**ADDENDUM****Addendum to MDS 05-2708A01, Rev. A****April 19, 2002**

This addendum contains corrections and additions to the MDS TransNET 900 Installation Guide (MDS P/N 05-2708A01, Rev. A) published in March 2002. The **Bolded text** below indicates new or revised material. You may wish to make these pen & ink changes directly to your manual or include a reference to this addendum in the appropriate sections.

### ITEM 7— New PORT Command

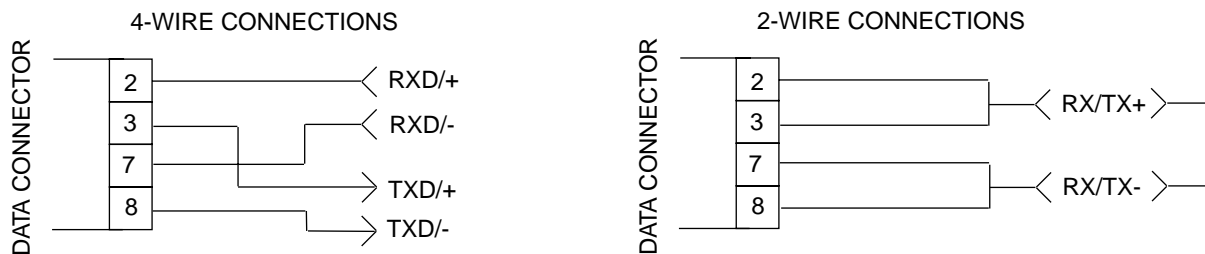
The transceiver’s DATA port configuration (RS-232 or RS-485) may be read by entering the **PORT** command. The port may be configured for RS-232 or RS-485 operation using the following commands:

**PORT RS232**—RS-232 operation

**PORT RS485**—RS-485 operation
